Re: St. Lucie Units 1 and 2
Docket Nos. 50-335 and 50-389
Fourth Ten-Year Interval In-Service-Test Program Submittal
RAI Reply to Relief Request PR-04 (TAC No. MD7748)

RAI Reply for Pump Relief Request – PR-04
Low Pressure Safety Injection Pump Group Classification

Attachment 2, Unit 1 LPSI Pump IST Vibration Data. (1 page)

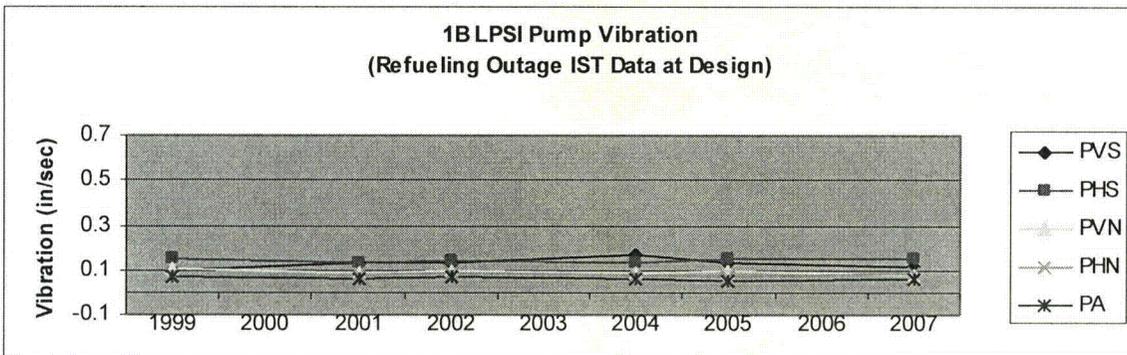
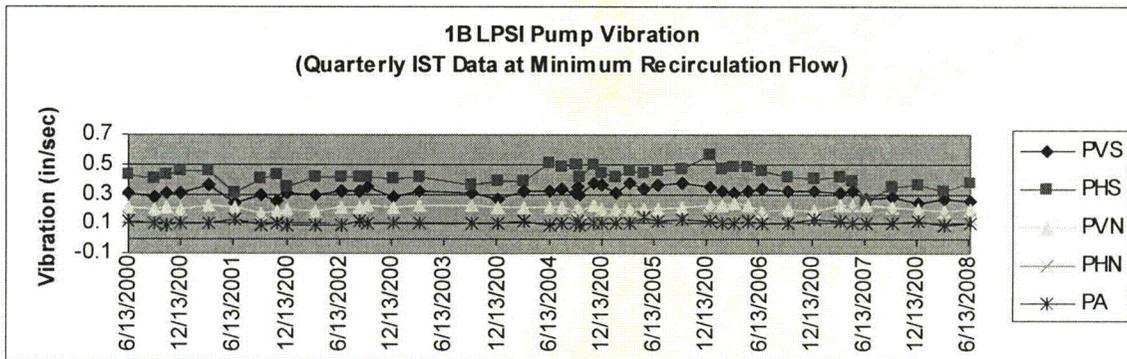
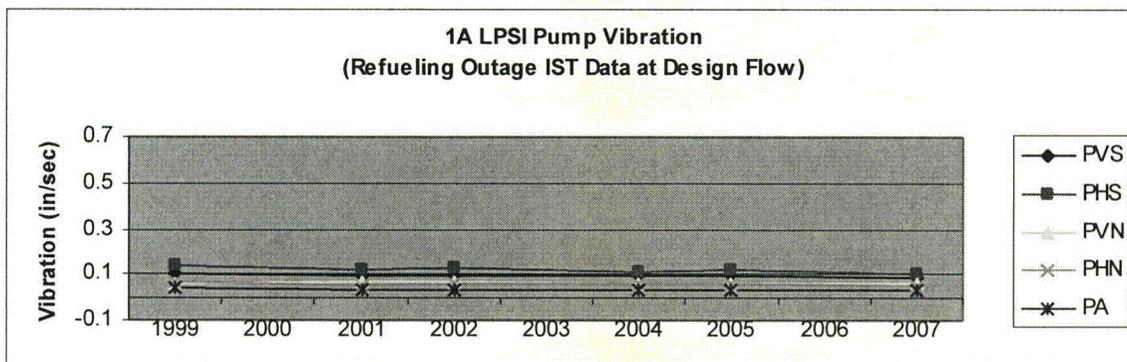
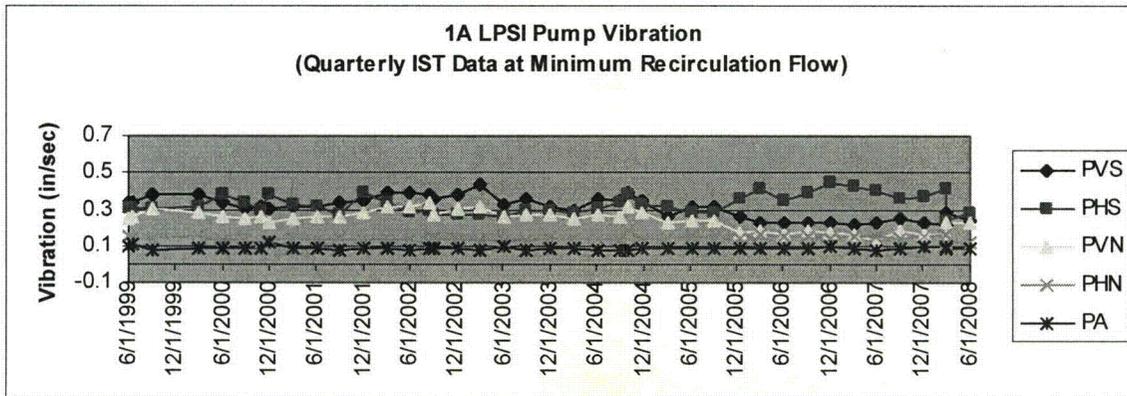
The following information is provided to supplement Relief Request Number “PR-04” submitted by Florida Power and Light Company under FPL Letter L-2007-144. This information is provided based on a telephone conversation between the NRC and FPL on July 2, 2008. Specifically, the NRC requested that the licensee provide basis and details for accepting the higher vibration values of 0.325 in/sec to 0.5 in/sec seen while testing the Unit 1 low pressure safety injection (LPSI) pumps under mini-recirculation flow conditions as described in previous PR-12 during the 3rd 10-year interval IST program. Additionally, the NRC requested that St. Lucie describe additional non-Code monitoring and spectral analysis activities performed on the LPSI pumps under design flow conditions during outages.

The Unit 1 LPSI pumps have been tested quarterly at minimum recirculation flow and during cold shutdowns at design flow in accordance with previously approved Relief Request PR-12. Attachment 2 shows the overall vibration values obtained during this testing. These trends show that vibration levels during recirculation are higher and more unstable than those obtained at design flow. The vibration levels at design flow have been well below the 0.325 in/sec Alert limit and stable.
